**Re: Swan River Resource, Permit M-1993-035, Technical Revision Approval, Revision TR02**

RE: REQUEST FOR TECHNICAL REVISION  
Mine Name: Swan River Resource  
Mine ID# M-1993-035  
Location: Summit County

# Swan River Resource (M-1993-035) Reclamation Restoration Reaches Within Permit Boundary

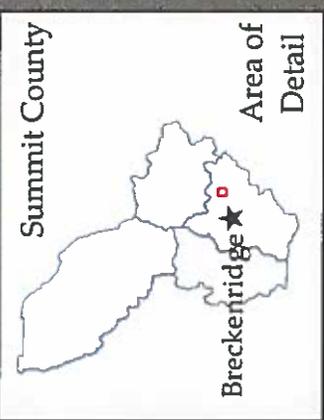
A conceptual design for approximately 3,000 linear feet of upstream restoration (Reach B) has been created within the permit boundary for a subsequent project phase that follows a similar approach to Reach A. Final design details will be provided to DRMS in advance of commencing this upstream restoration reclamation work. The timing of restoration reclamation work on Reach B is not finalized and largely dependent upon funding. Following completion of the restoration reclamation on Reach A, the County will seek to release this acreage from the permit boundary.
